SERVICE BULLETIN

No. 232

Piper Aircraft Corporation

SUBJECT: Inspection of Brake Disc Assembly

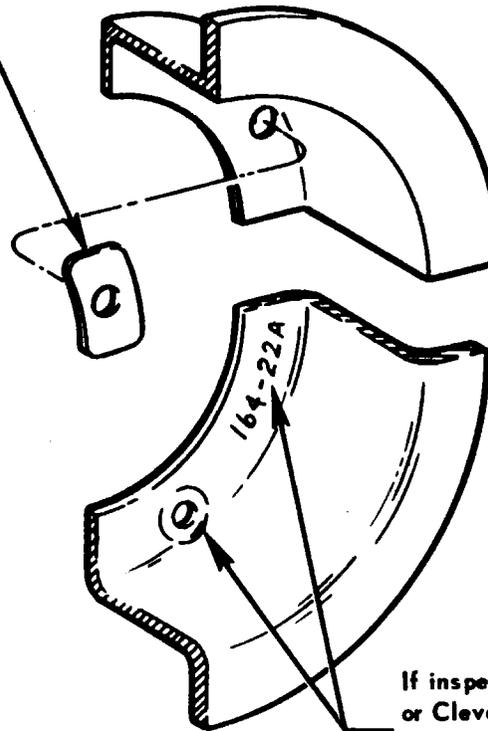
Brake disc assemblies that are not spot faced or are not identified by Cleveland Aircraft Products Part No. 164-22A must have Kit 757 039 installed. (A special washer and an AN5-36A bolt are included in this Kit.)

Inspect for cracks with 10 power glass or equivalent in these areas.

If inspection reveals .562 spot face, or Cleveland Aircraft Products Part No. 164-22A, no further action is required.
